Re: Butte Blackjack Operating – Exploration License Application Modification

Butte Blackjack Operating is submitting the following modifications to the Butte Project Exploration License Application via this transmittal letter:

Missoula Drill Site
Blackjack Project
Butte, Montana
FIGURE 2

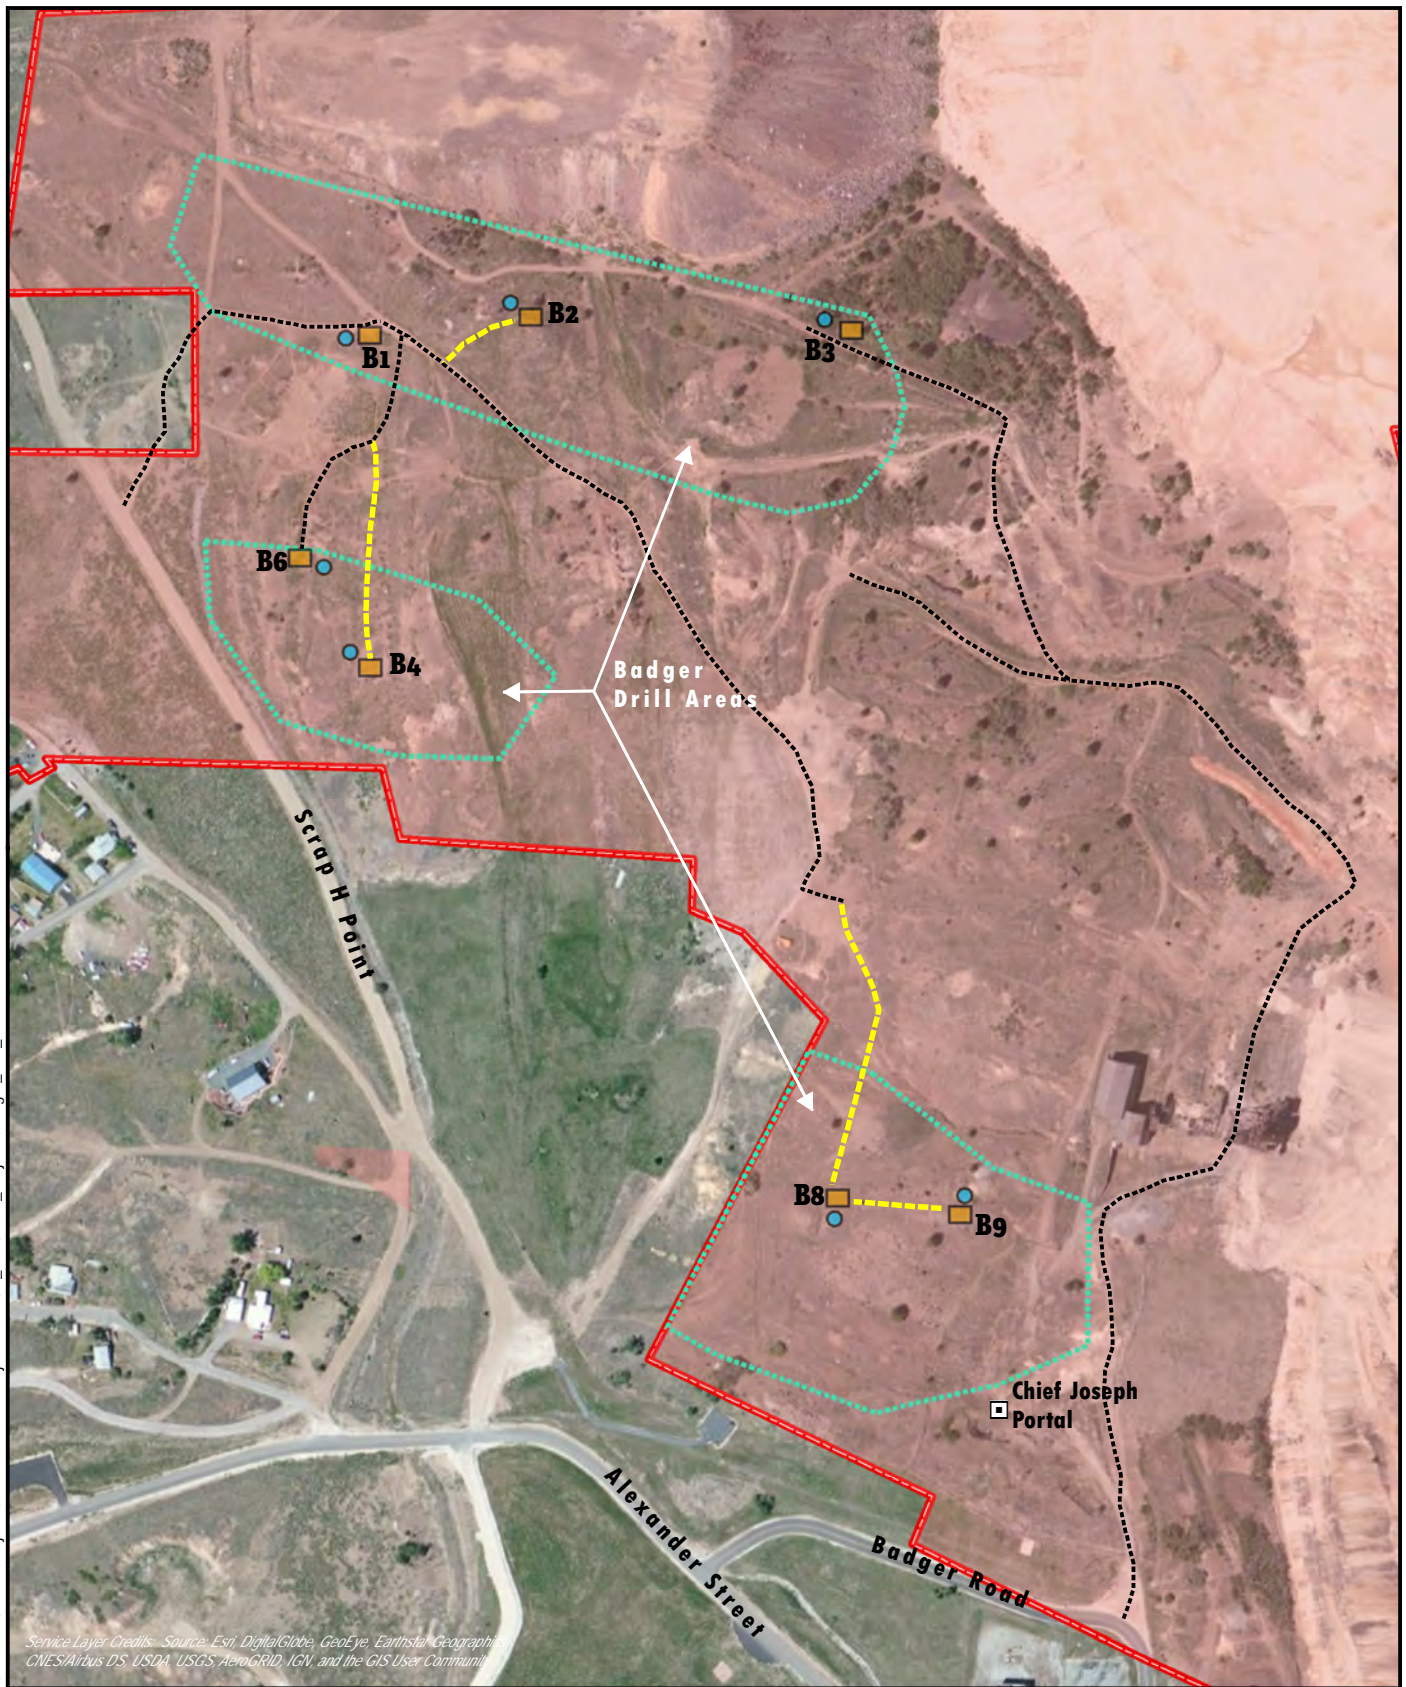
- Lease boundary has been revised in response to accurate land ownership and survey information;
- Drill site M-1 has been deleted from the plan;
- Map depiction of drill sites M-2, M-3, and M-4 has been revised in response to actual surveyed locations; the sites staked in the field have not changed.
